**Federal Highway
Administration**

This is in response to your November 5 letter requesting that the Federal Highway Administration (FHWA) issue a letter of acceptance for your company's "Triton" water filled barrier. On that date you met with representatives from the FHWA's Office of Research, Office of Engineering, and Office of Safety and Technology Applications to introduce the barrier and show crash test films. You also provided a November 1992 report of the crash testing you conducted and attested to by William H. Kimball, an independent professional engineer.

TRITON BARRIER
MOLDED PART

Your December 14, 1993, letter requested the Federal Highway Administration's (FHWA) acceptance of the TRITON Barrier as the barrier's own end treatment. Details of the design and crash tests results were included in your "TRITON Barrier End Treatment Crash Test Report" dated December 1993.

TRITON Installation Deflection Curves

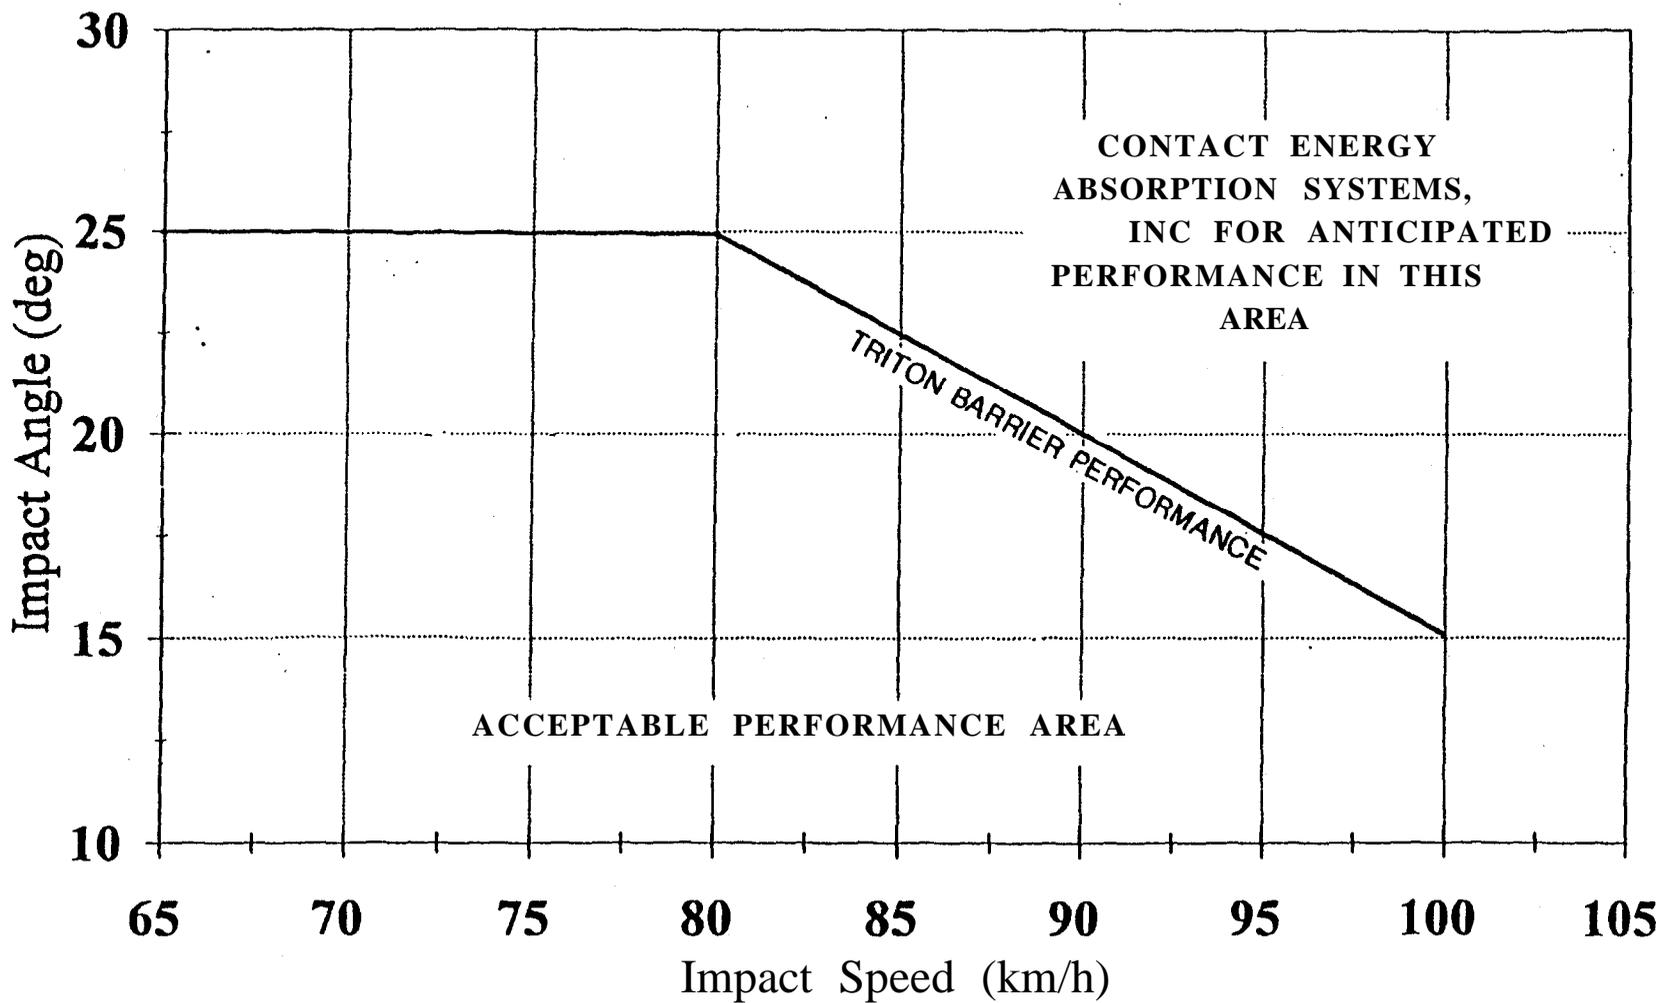
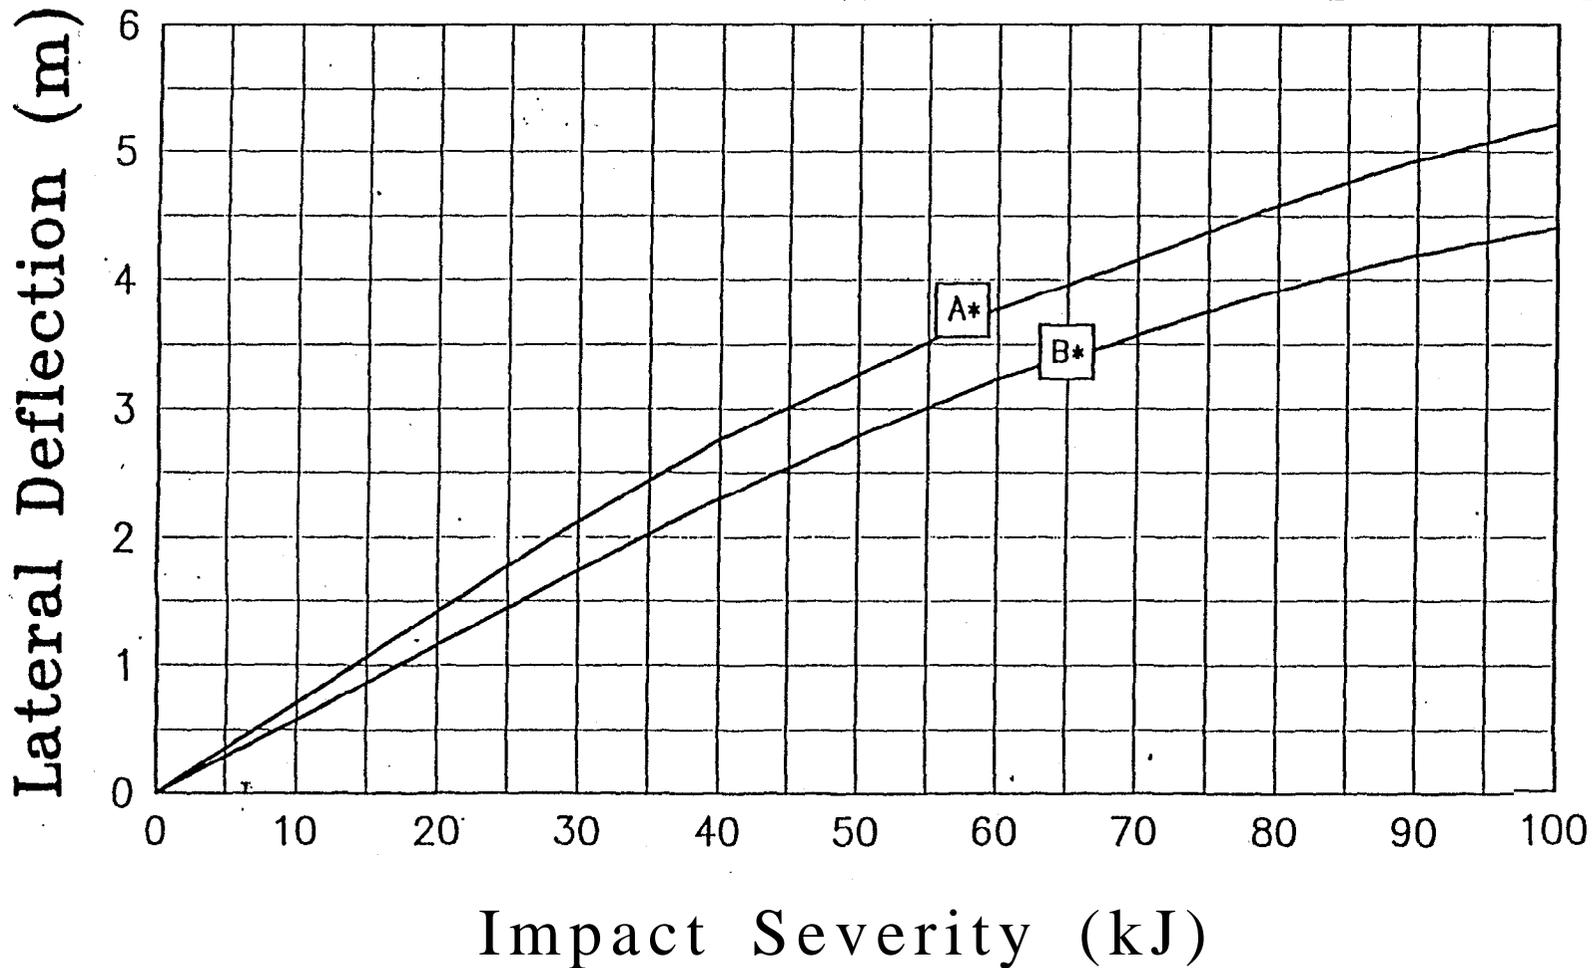
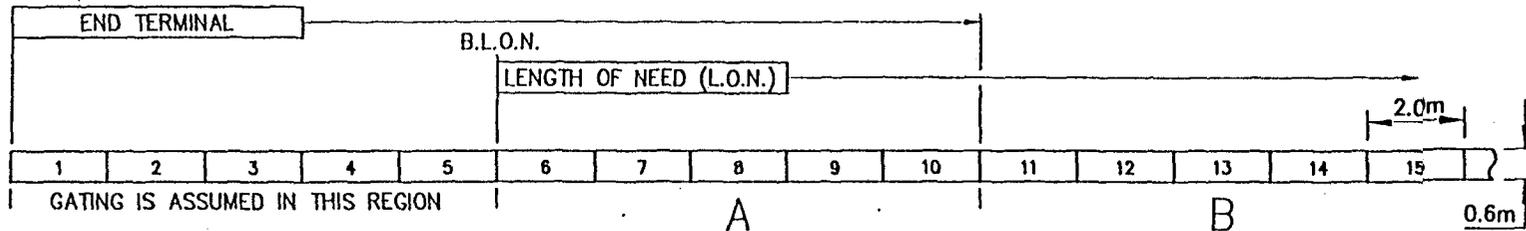
In all of the cases suggested above, the roadside surface condition and the available deflection distance from the barrier to fixed objects, edge drop-offs, and workers must be consistent with TRITON performance characteristics. This determination can be made from the deflection-impact severity curve which was submitted with your request and will be sent to FHWA field offices with a copy of this letter.
